**NEW SAVANNAH BLUFF
LOCK AND DAM
PROJECT SAVANNAH RIVER
GEORGIA AND SOUTH CAROLINA
FISH PASSAGE FACILITY
ENGINEERING REPORT**

**Prepared for:
U.S. ARMY CORPS OF ENGINEERS**

**Prepared by:
FRAMATOME ANP DE&S, INC.**

Re: New Savannah Bluff Lock & Dam Fish Bypass System
Engineer Report 35 Percent Design – Final Submittal
Purchase Order No. DACW01-00-D-0019

FIGURE 9

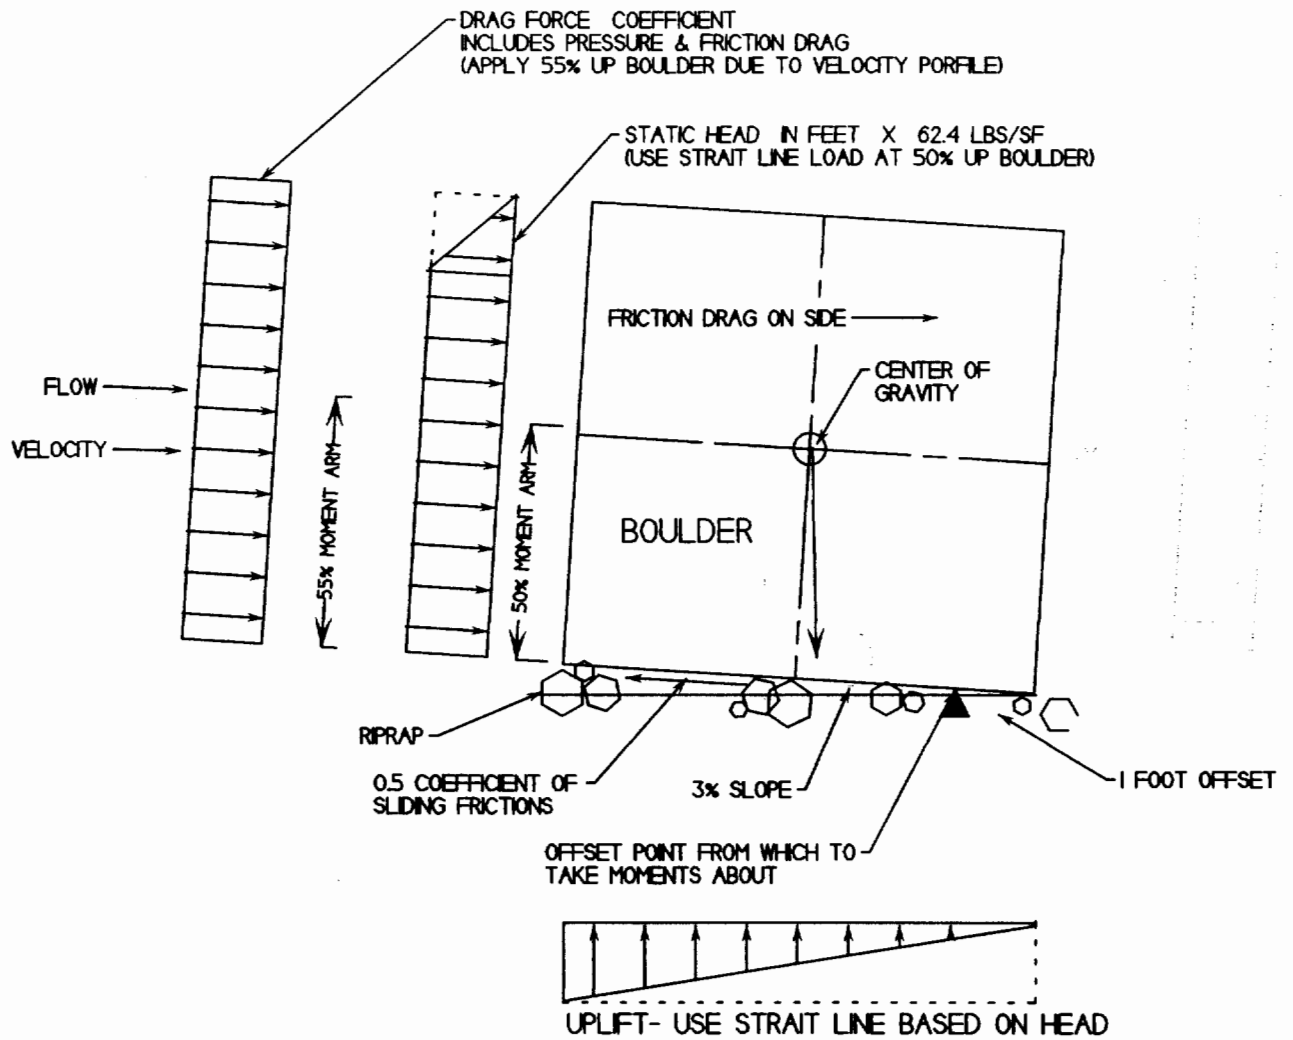
Is the hydrostatic pressure right on Figure 9 ???
